Two-Piece Clutch Brake, Replacement

M-411-001

(December 2008)

All CXU,CHU,GU models equipped with an air-assist clutch.

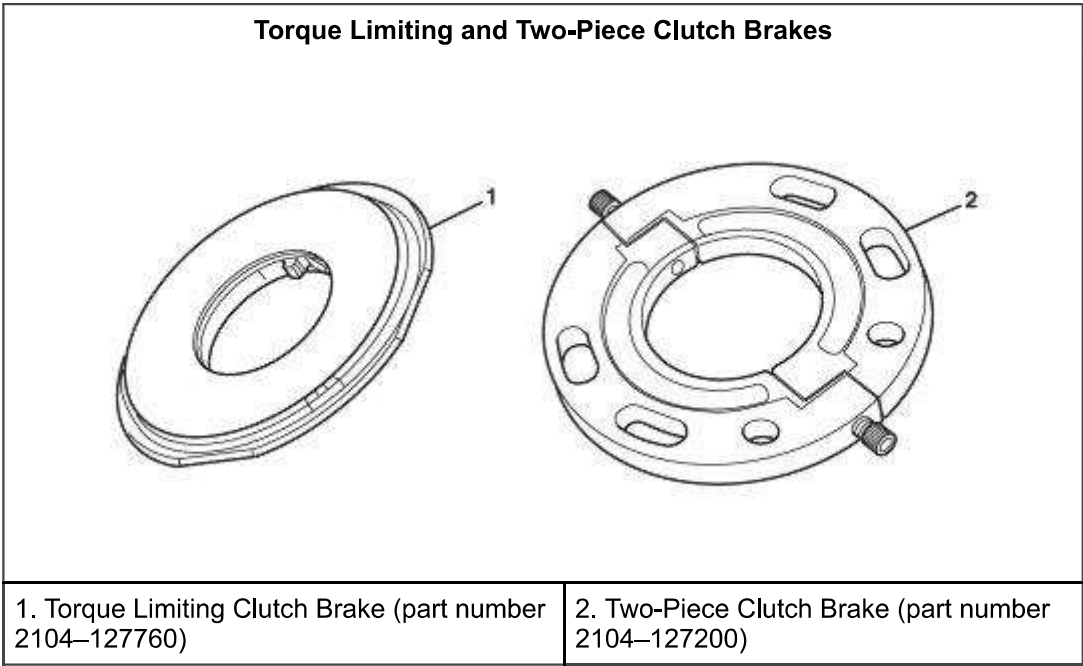
Should failure of a two-piece clutch brake assembly (part number 2104–127200) be experienced on a CXU, CHU or GU model chassis equipped with an air-assist clutch, it is recommended that the single-piece clutch brake assembly (part number 2104–127760) be used as the service replacement. Additionally, after replacing the clutch brake, always ensure that the clutch is properly adjusted according to the instructions outlined in service bulletin SB313005. Maintaining proper clutch adjustment will prolong the life of the clutch and clutch brake assembly, regardless of make or model of the clutch components.
